VILLAGE OF HOMEWOOD

MEMORANDUM

Topic: Case 26-34: Appearance Review for 7Brew Drive-Thru Coffee, 17855 Halsted Street

2 Planting Prototype, Parking Lot with Buffer

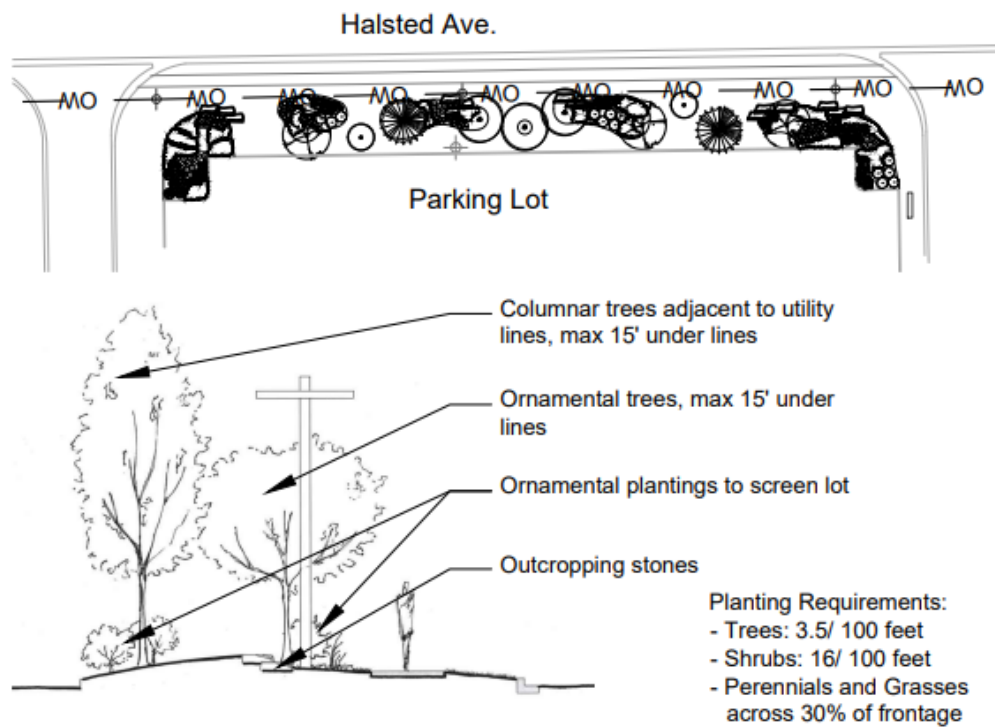
The applicant must also meet the minimum requirements of the 2015 Halsted Street Corridor Landscape Plan. This site would be subject to the planting prototype for a parking lot with a buffer, as found in Exhibit 2 of the landscape plan (shown below).

- Tree plantings (minimum 3.5' per 100' frontage) – 13 trees minimum (**met**)
- Shrubs – 57 shrubs minimum (**not met**)
- Perennials or native grasses – across 30% of the frontage (**not met**)

Staff has recommended a condition of approval to require the addition of shrubs/native grasses and understory/evergreen trees to meet the recommendations of the Halsted Street Corridor Landscape Plan. See Recommended Appearance Commission Action.
